MERCURY Racing parts bulletin MERCURY MerCruiser

No. 2001-5

Alpha Replacement Shift Cable

All MC-I, R, MR, Alpha One and Alpha One Gen II

a - Older style shift cable core wire with round anchor
b - Newer style shift cable core wire with hexagonal anchor

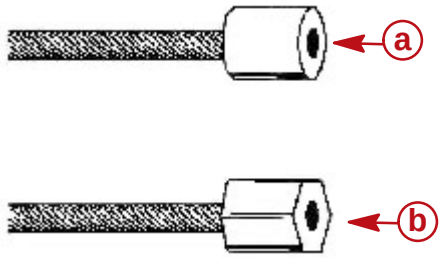
The newly redesigned Alpha intermediate shift cable may experience stiff shifting caused by binding at the aft end of the cable. If the binding occurs, the stiff shifting could cause the engine to stall. The binding is caused by the hexagonal shaped anchor attached at the aft end of the cable. This hexagonal anchor has a slightly larger outside diameter than the older style round anchor. Due to the larger outside diameter, there may be an interference fit between the hexagonal shape cable anchor and the inside of the shift slide. **Note: Shift slide must rotate freely on core wire to prevent hard shifting and/or engine stalling when shifting the drive.**

Inspect your inventory of the following shift cable assemblies P/N 19543A 8 and P/N 19543T 1. If the cable core wire has a round shaped anchor, your inventory is good and it does not need to be replaced. If the shift cable core wire has a hexagonal shaped anchor, it must be returned to Mercury Marine for credit.

P/N 19543A 8 will be superceded to P/N 19543A10 and P/N19543T 1 will be superceded to P/N 19543T 2. The new superceded P/N 19543A10 and P/N 19543T 2 include the new style shift cable core wire with the hexagonal anchor and the new modified shift slide P/N 850752 2 designed to accommodate the larger hexagonal anchor.

The shift slide P/N 850752 1 can be used up with the older shift cables that have a round core wire anchor. The P/N 850752 1 will be superceded to P/N 850752 2. The initial modified shift slides P/N 850752 2 will be identified by a yellow paint dot on the starboard side of the shift slide. The later shift slides will be identified by a “2” cast in the top of the shift slide.

P/N 19543A10	Shift Cable Assembly – replaces 19543A 8
P/N 19543T 2	Shift Cable Kit – replaces 19543T 1
